WEC Project Reference: 24106

Stormwater Drawing & Construction Review Memorandum for 142 Konini Road, Titirangi

Drawing No: **3368-RC-01** Rev: **C**

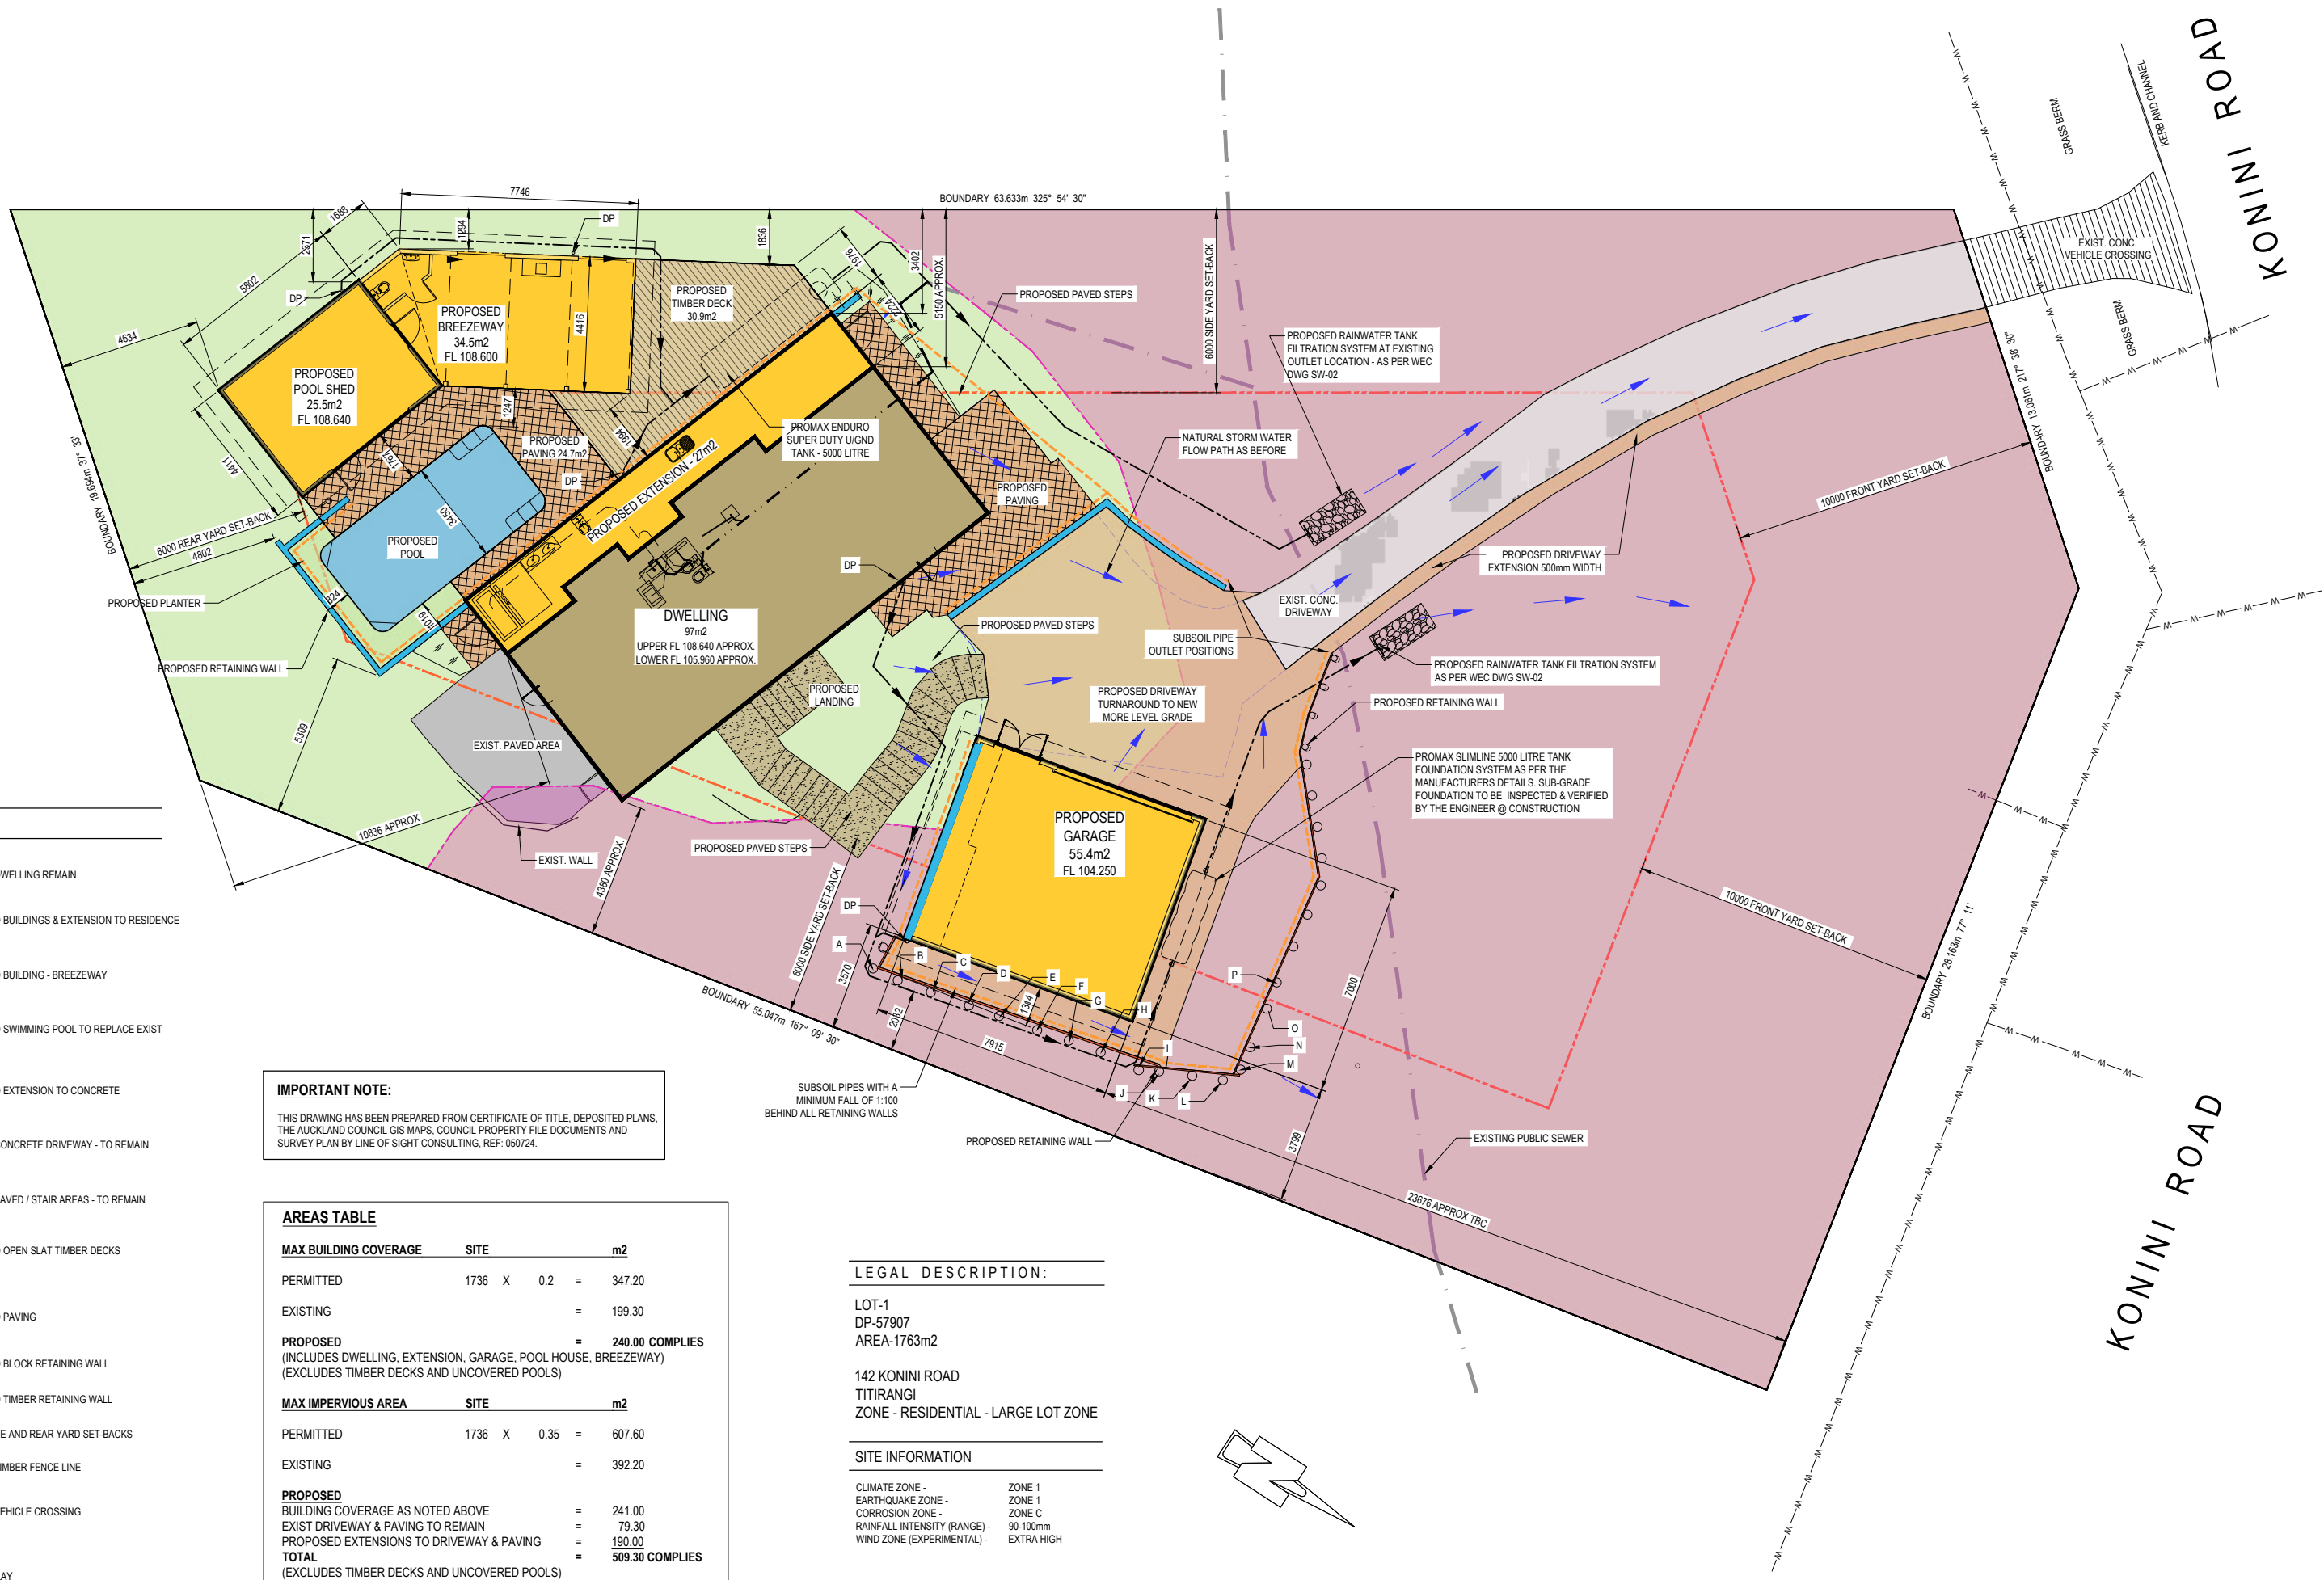
Natural Overland Flow Path	Maintain natural overland flow path for permeable areas; vegetation away from new impermeable areas to be retained. Demolished existing building areas are to be replaced with vegetation/shrubs.	New drawings indicate flow paths consistent with pre-development conditions. Vegetation/shrubs/native plants are to be planted in front of the newly constructed retaining walls as well as in the areas where existing structures have been removed. Acceptable.
Subsoil Pipes Behind Walls	Provide subsoil drains behind retaining walls with outlets to the stormwater system, ensuring discharge is away from neighbouring properties.	The latest drawings show subsoil pipe positions and outlet locations that are directed away from neighbouring properties. Once permanent works are complete, exit subsoil flows will be minimal due to the minimal catchment areas. Acceptable.
Note: The drawing and report set relevant to these reviews are the RC Drawings 3368-RC-01 to 02, WEC's Stormwater Report and Engineering Drawing Sheet SW02.

SITE PLAN – OVERLAY OF EXISTING AND PROPOSED CONDITIONS ILLUSTRATING STORMWATER MANAGEMENT

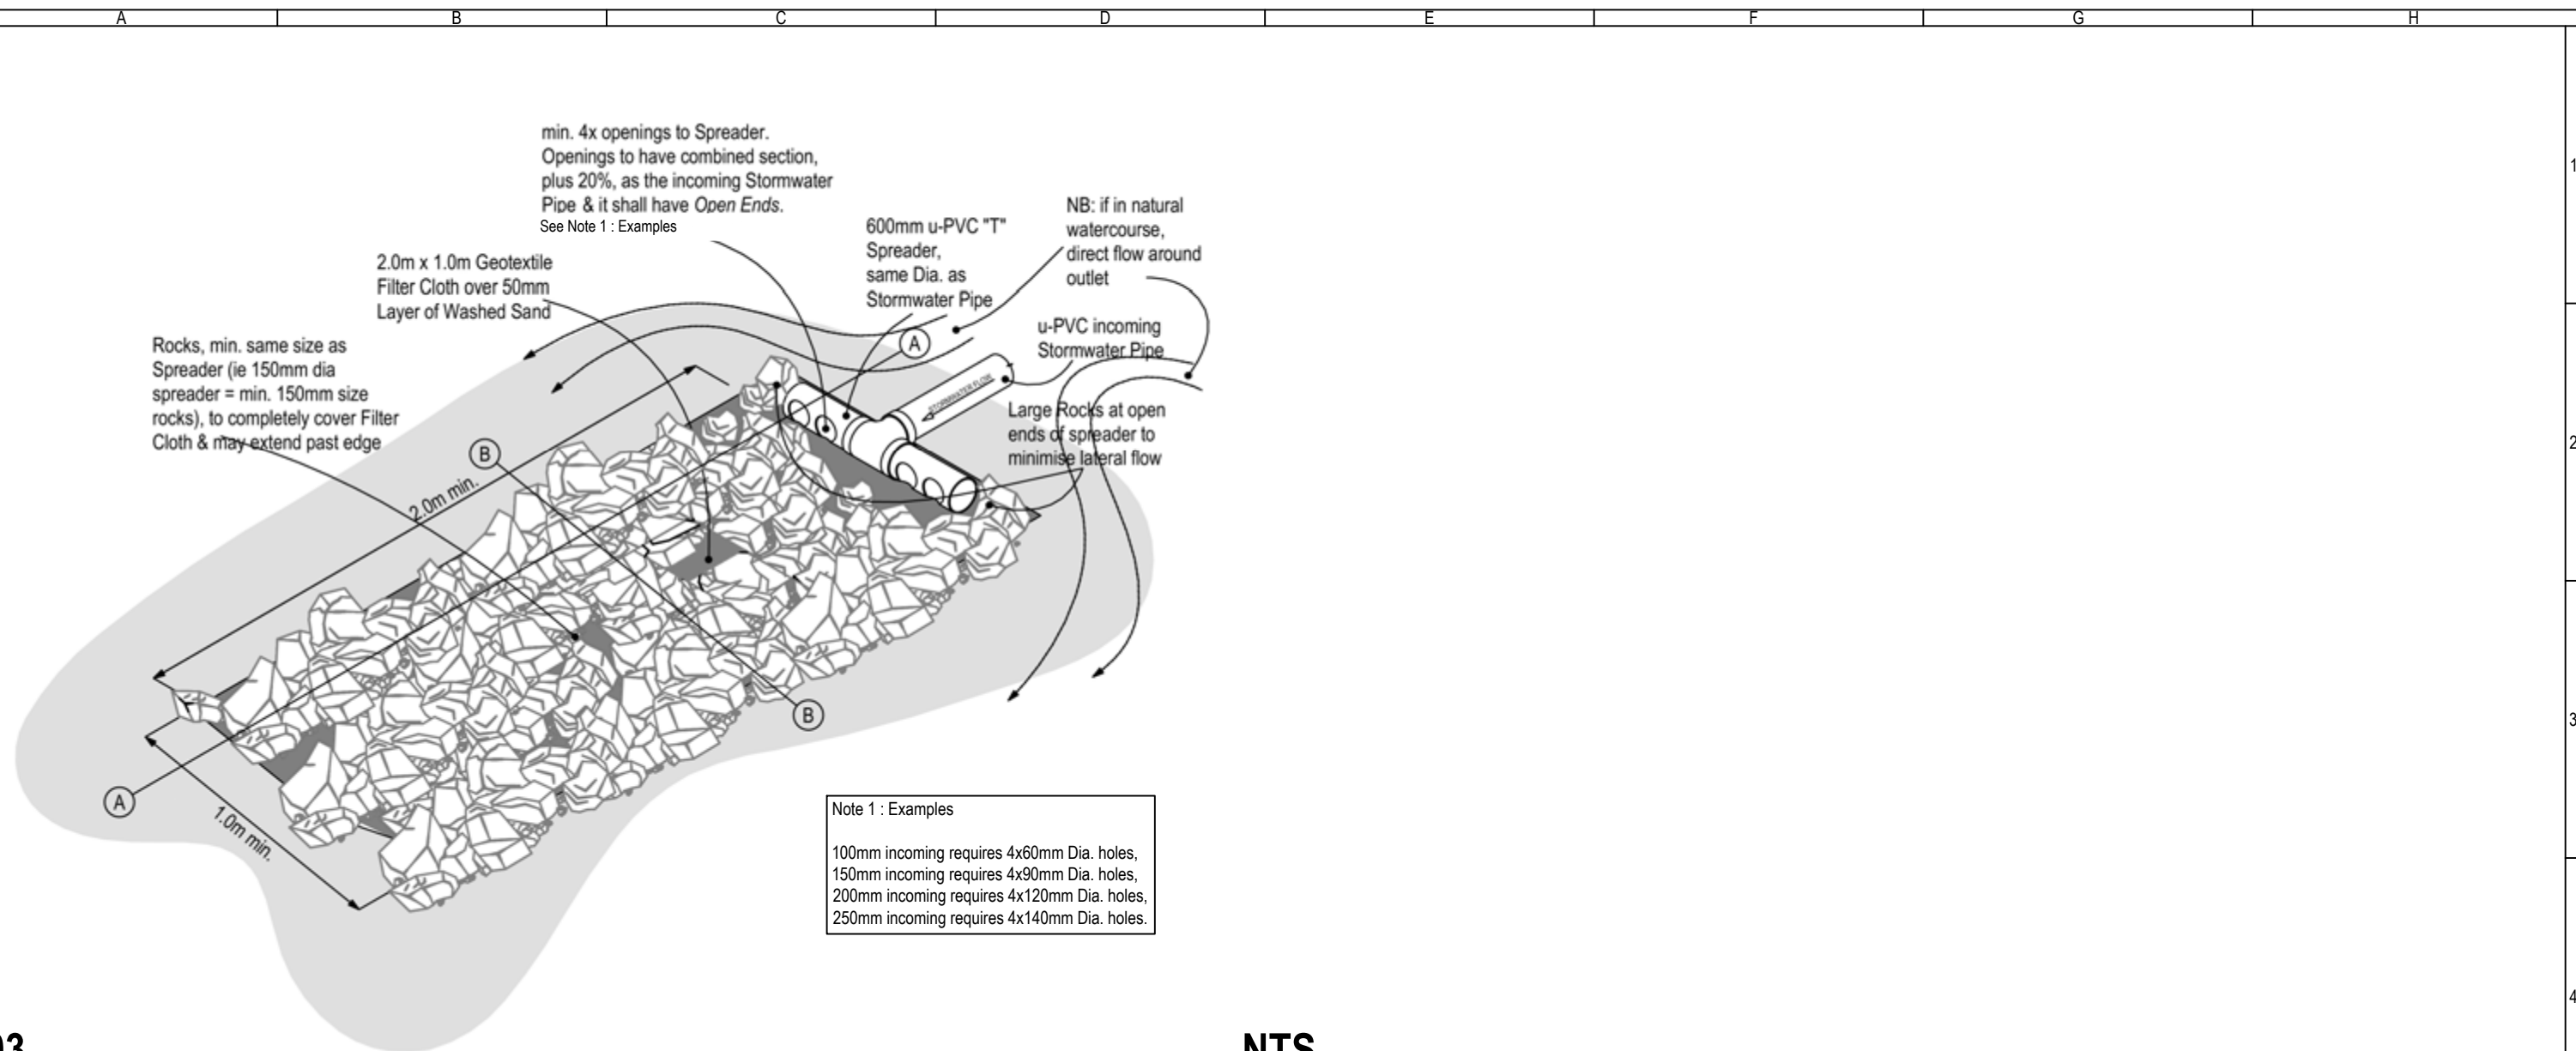
- **Overlay of Existing and Proposed Plans:** The existing site plan has been overlaid with the proposed development layout on Sheet SK10 (Appendix A). This illustrates how the stormwater management system integrates with the proposed changes, highlighting the extent of impervious surfaces, retaining structures, and new drainage outlets. Such overlays are critical for comparing pre and post-development hydrological conditions and for verifying compliance with the design intent.

- **Replanting of Shed Removal Areas:** Areas where the existing pool shed and ancillary shed have been removed remain exposed and unvegetated. Without stabilisation, these surfaces act as compacted subgrade with high runoff coefficients ($C = 0.7\text{--}0.9$), leading to increased runoff and a higher risk of sediment mobilisation. Re-planting with dense vegetation or groundcover will restore infiltration capacity ($C \approx 0.3$), reduce peak runoff, and provide erosion control, particularly given the influence of upslope contributing flows.

Removed existing pool shed area to be landscaped with dense native plants, shrubs or similar vegetation

Removed existing shed area to be landscaped with dense native plants, shrubs or similar vegetation

Subsoil pipe T exit to be maintained with native plants, shrubs or similar vegetation.

Area in front of new wall to be landscaped with native plants, shrubs or similar vegetation

ESC EROSION & SEDIMENT CONTROL FOR EXISTING SITE: PLAN
Scale 1:400

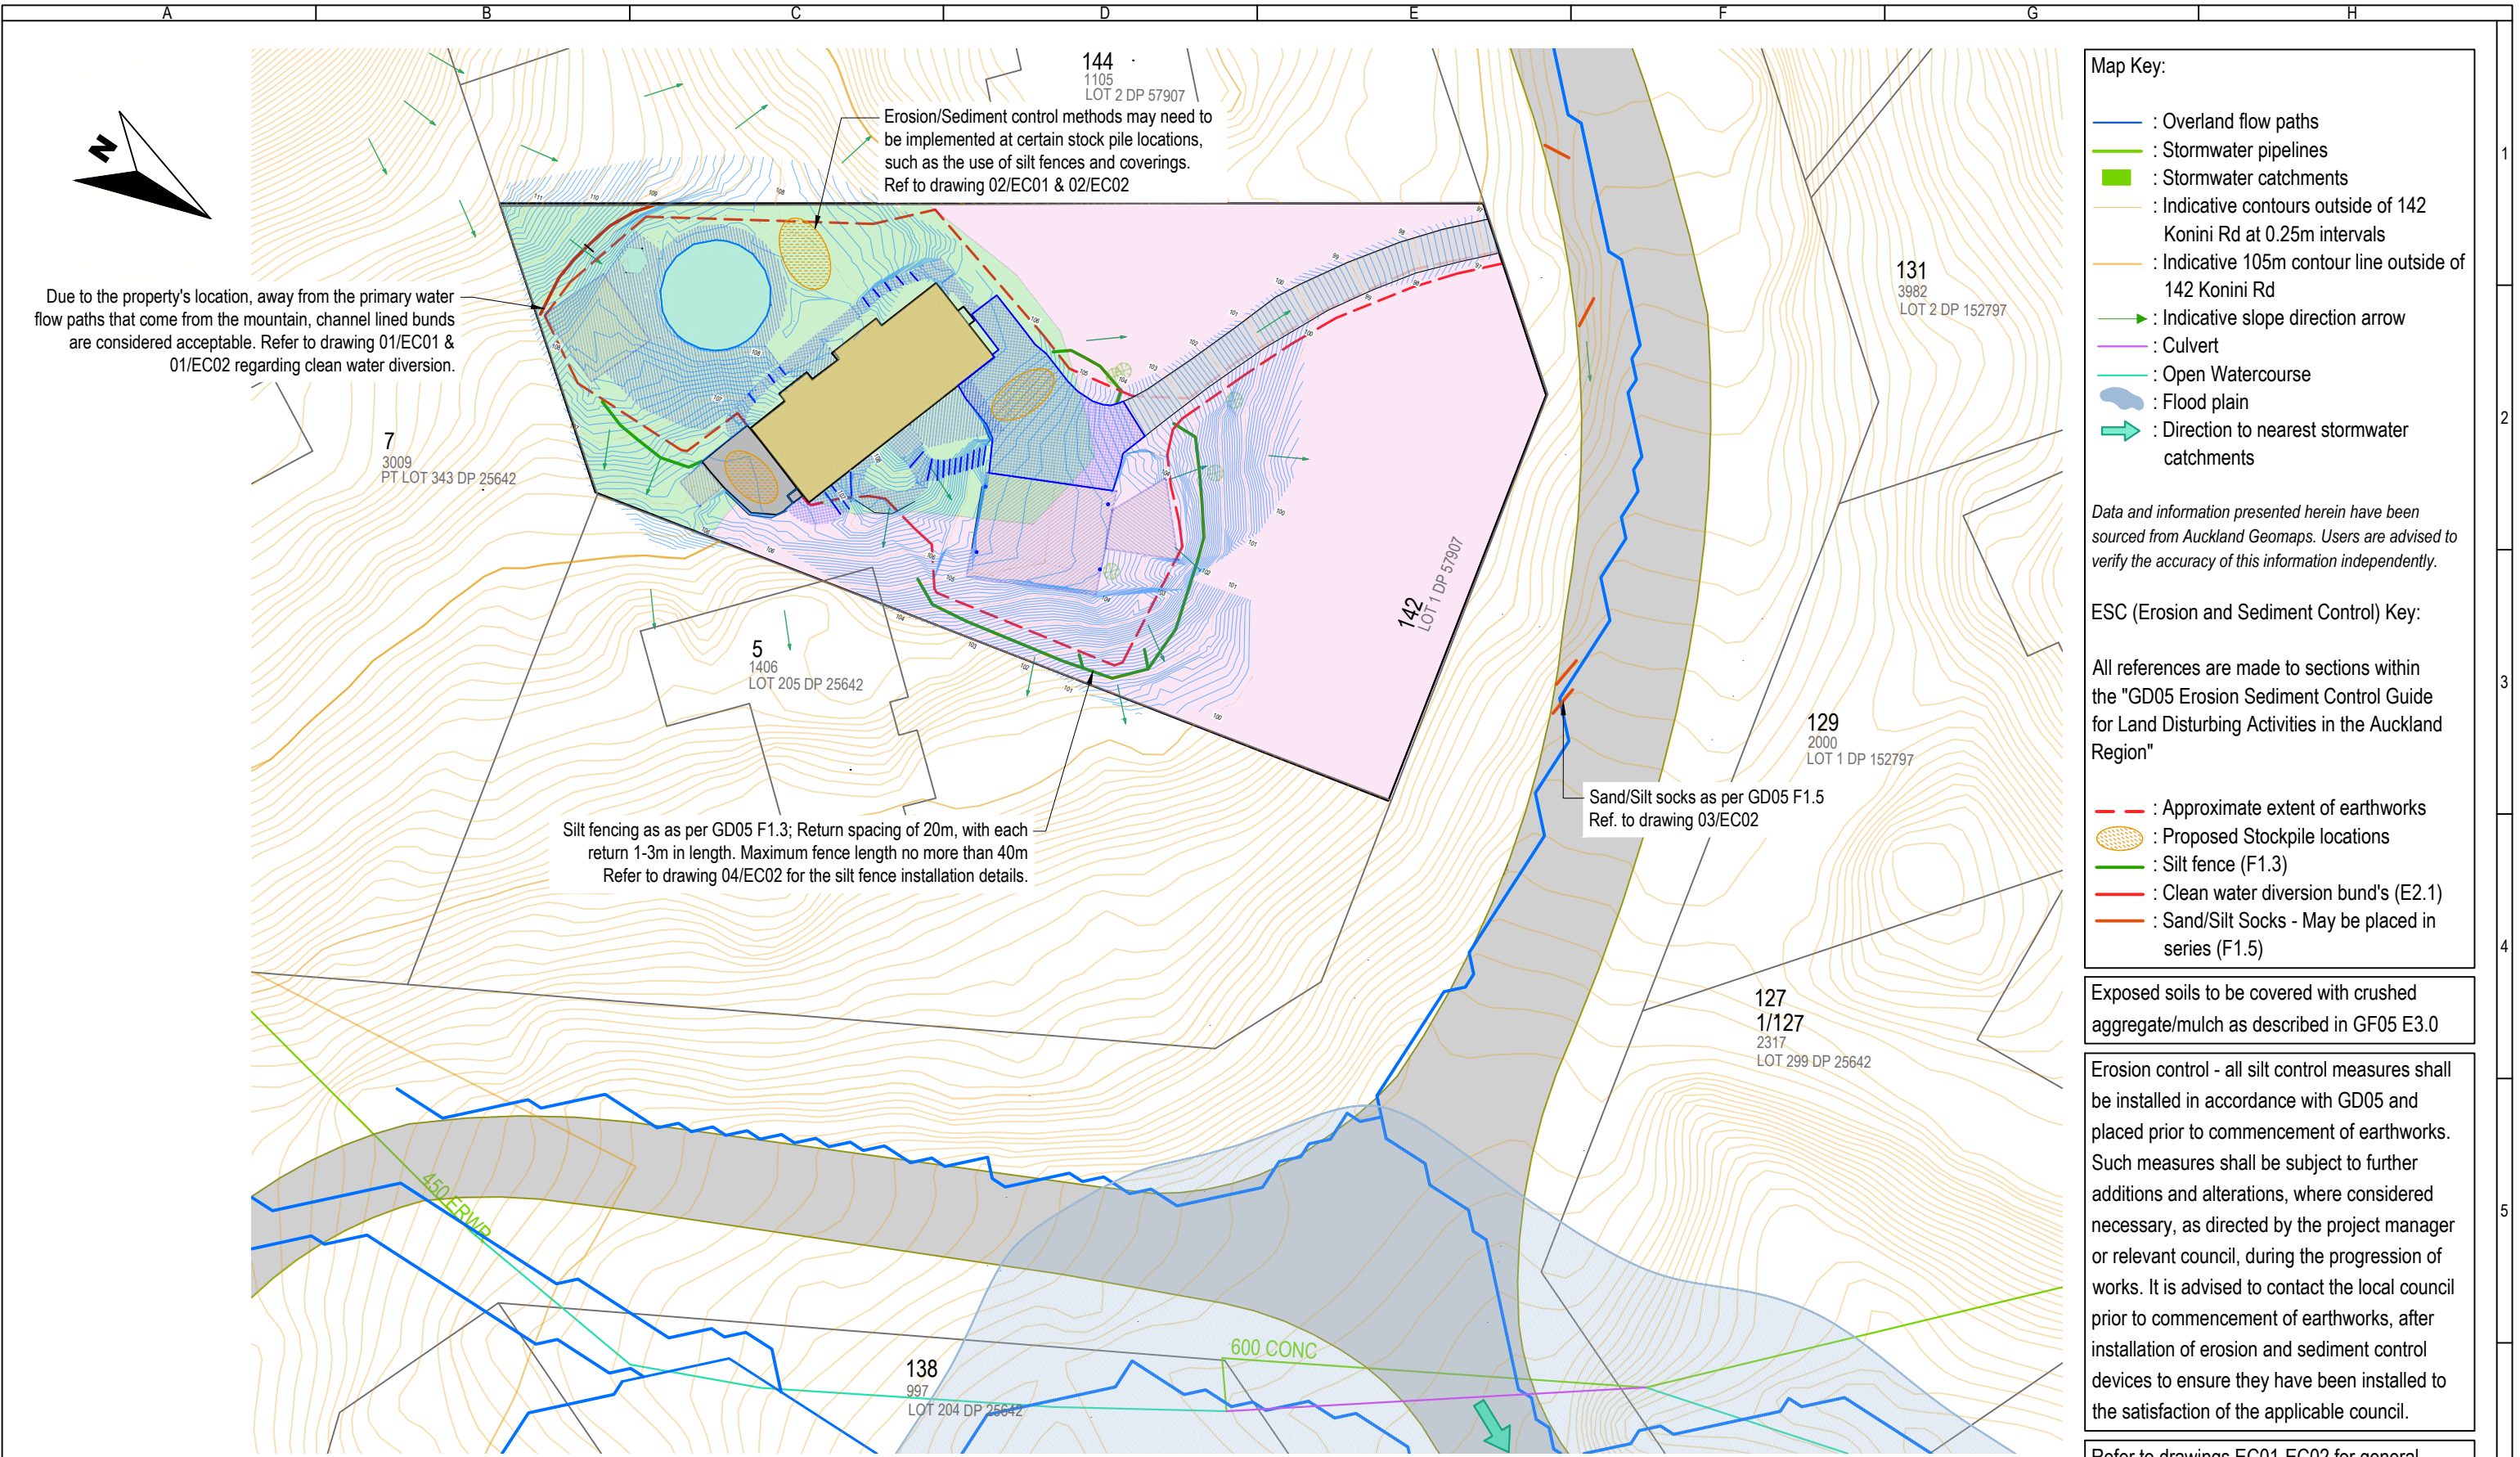
- **Erosion and Sediment Control Measures:** Not all temporary erosion and sediment control measures specified on the drawings have been implemented. In particular, a temporary bund is required at the southern boundary (Sheet ESC) to intercept and redirect overland flow away from the neighbouring property at 5 Konini Road. The absence of this measure presents a risk of uncontrolled runoff during storm events, potentially resulting in localised runoff, erosion, and neighbour complaints.

1. Install temporary erosion and sediment control measures, including the bund on the southern boundary as shown on Sheet ESC. Provide photographic evidence to the Engineer once complete.
2. Plant dense vegetation in areas where buildings have been removed and no future works are proposed, and also adjacent to the retaining walls. Provide photographic evidence to the Engineer once complete. The photographs will be attached in Appendix D of the report to illustrate that the measures are in place.
